**From:** [REDACTED]  
**To:** [REDACTED]  
**CC:** [REDACTED]  
**Sent:** 3/23/2021 4:49:34 PM  
**Subject:** RE: O8W-PM 35217268, 35224712, 35224713 - Bucks Creek 1101 Phase 1,2&3 - Pre-Engineering Meeting

# Bucks Creek 1101- PM# 35217268 Overview Map

PM 35217268 (Phase 1)

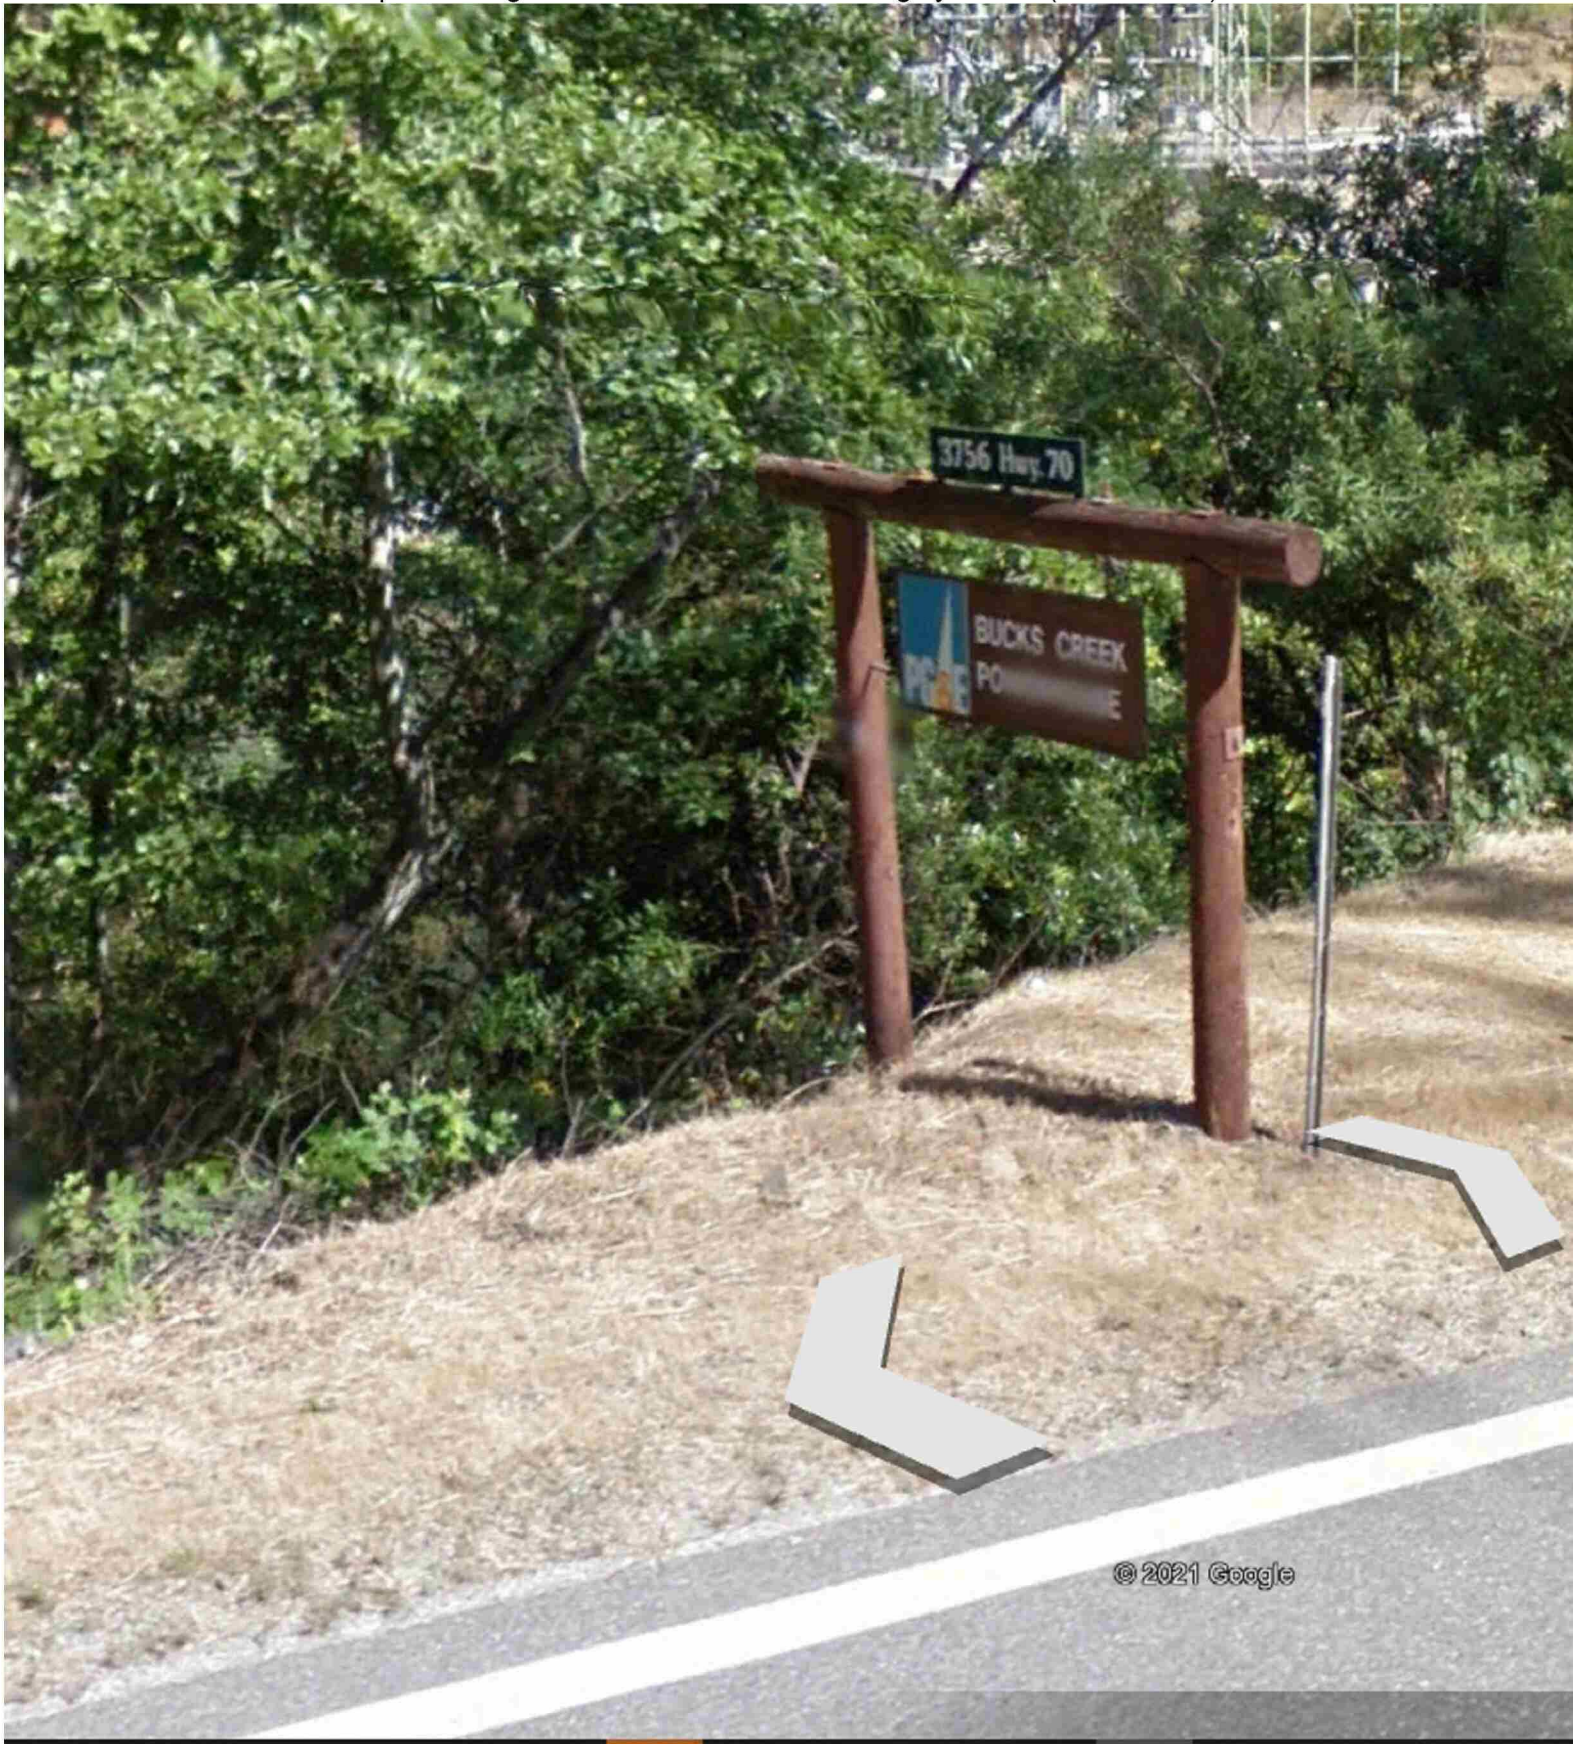
Attached are the 'base-map' limits in a kmz. file. As you will see, we need our base-map to go about ~100' into the tunnel at the south end (see pedestal in picture below....please begin about ~50 beyond this point which is about ~100' beyond the Cresta Dam).

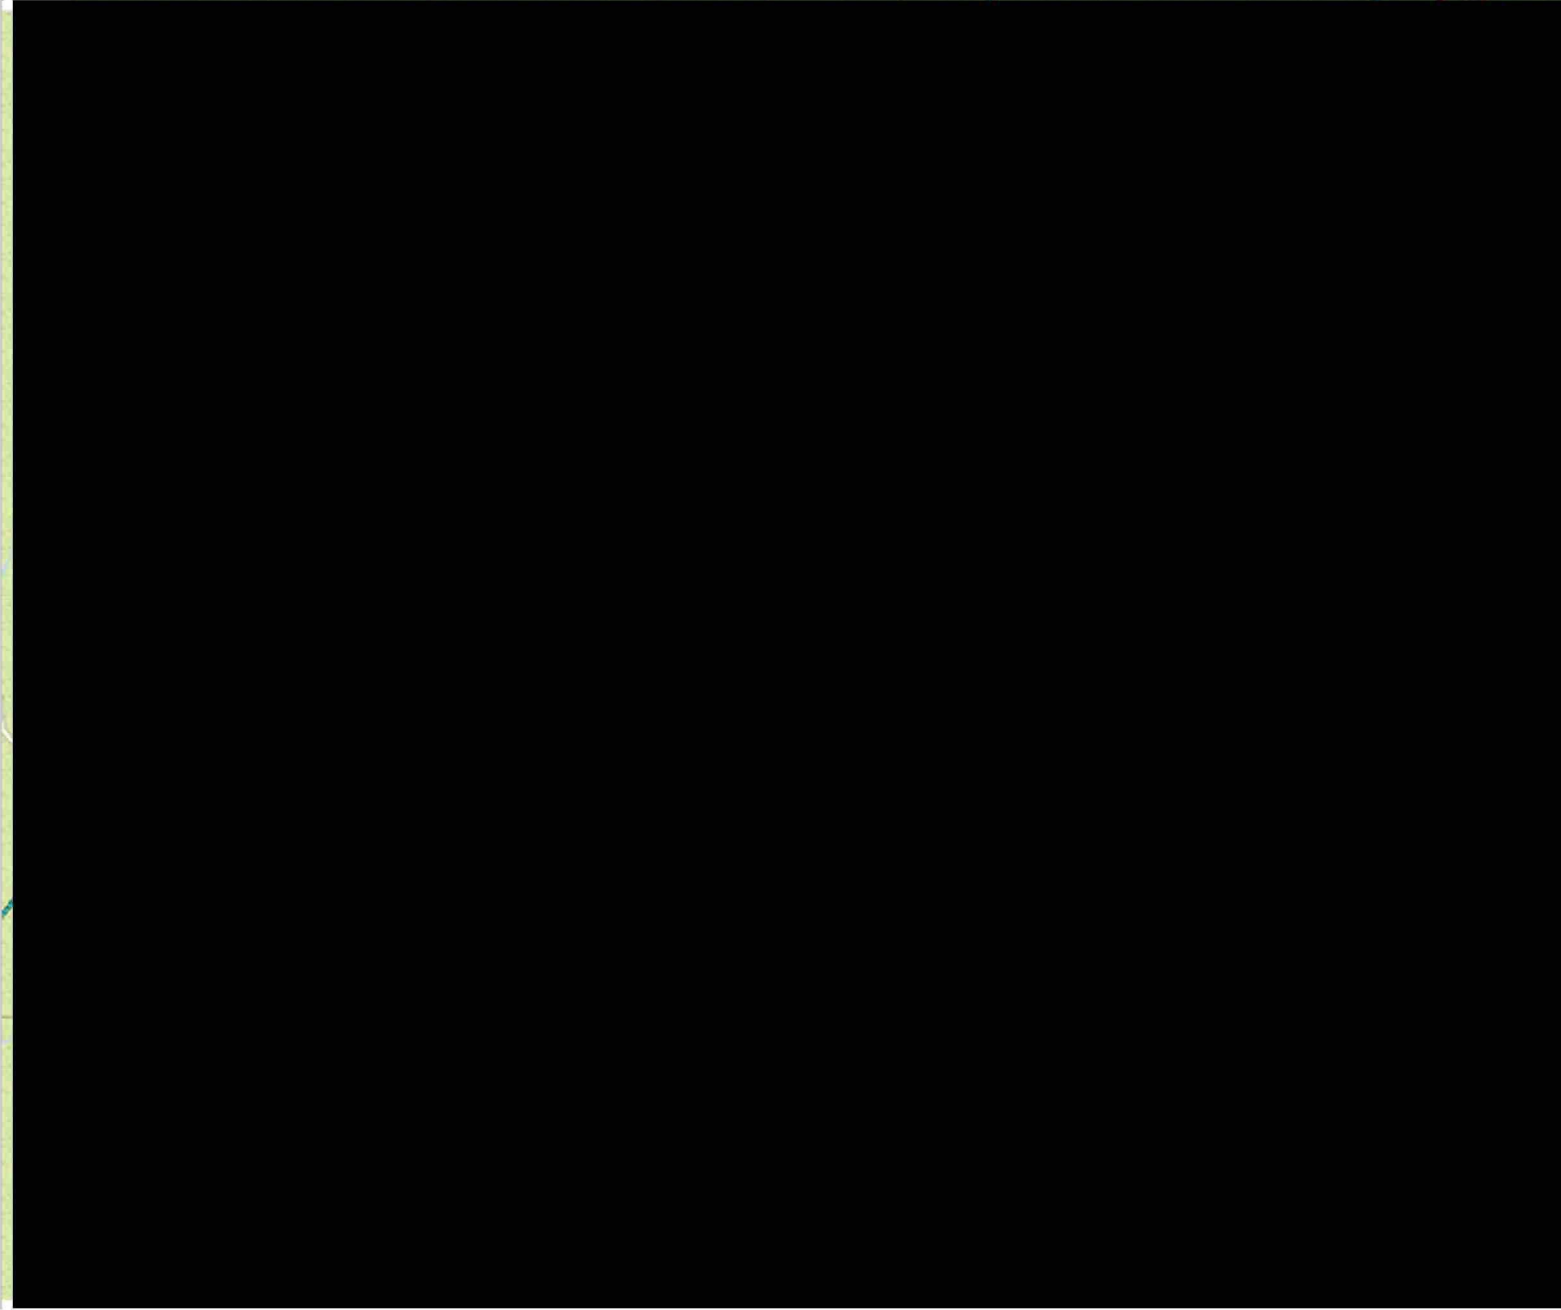
For Bucks Creek there is quite a bit of work surrounding Hwy 70 and we will need a Land Department Base Maps prepared for all 3 Orders. This will delay the EOD dates until these can be developed and provided to the Vendor... We will also need answers to the questions outlined by [REDACTED] below...
